# Access Compliance Report

## Public Rights-of-Way

### (Curb Ramps)

Intersection ID: N/A	Main Street: E_W_T_HARRIS_BV	Cross Street: N/A	Location: SE
ADA ID: C4CAA79757B2	Ramp Type: PerpDiag	Initial Pass/Fail: Fail	Overall Compliance: No
		Severity Score: 12.5

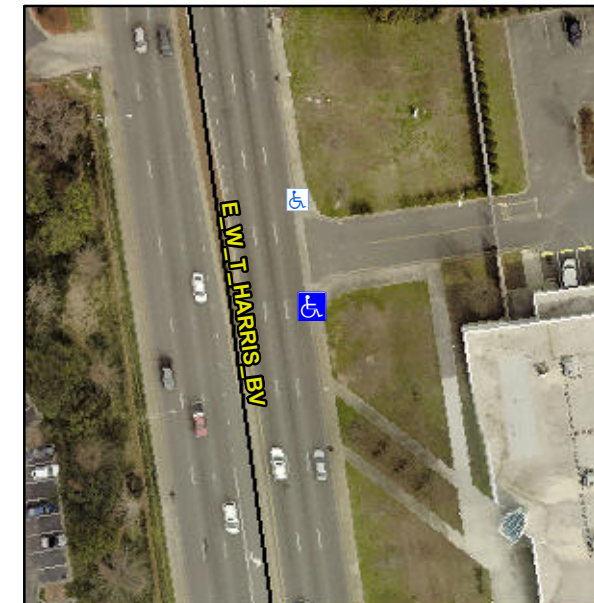
Compliance	Description	Data	Compliance	Description	Data
N/A	Ramp Length (in)	71.0	No	Ramp Slope (%)	9.4
Yes	Ramp Width (in)	54.0	Yes	Ramp XSlope (%)	1.8
N/A	Flare Type LT	N/A	N/A	Flare Type RT	N/A
N/A	Flare Slope LT (%)	N/A	N/A	Flare Slope RT (%)	N/A
N/A	Flare Traversable LT?	N/A	N/A	Flare Traversable RT?	N/A
N/A	Landing Length (in)	N/A	N/A	DWS Provided?	N/A
N/A	Landing Width (in)	N/A	N/A	DWS Contrast?	N/A
N/A	Landing Slope (%)	N/A	N/A	DWS Length (in)	N/A
N/A	Landing X Slope (%)	N/A	N/A	DWS Full Width?	N/A
N/A	Landing Curb? (Y/N)	N/A	N/A	DWS Offset (in)	N/A
N/A	Shared Landing?	N/A			
N/A	Gutter Ponding?	N/A	N/A	Gutter Slope (%)	N/A
N/A	Gutter Lip Ht (in)	N/A	N/A	Gutter X Slope (%)	N/A
N/A	Painted X Walk1?	No	N/A	Painted X Walk2?	No
	X Walk 1 Direction	To N		X Walk 2 Direction	To W
N/A	X Walk 1 Width (in)	N/A	N/A	X Walk 2 Width (in)	N/A
	X Walk 1 Slope (%)	3.0		X Walk 2 Slope (%)	1.2
	X Walk 1 X Slope (%)	1.9		X Walk 2 X Slope (%)	0.9

**Remove & Replace Curb Ramp With Two New Directional Ramps or Equivalent.**

**R304.2.2**
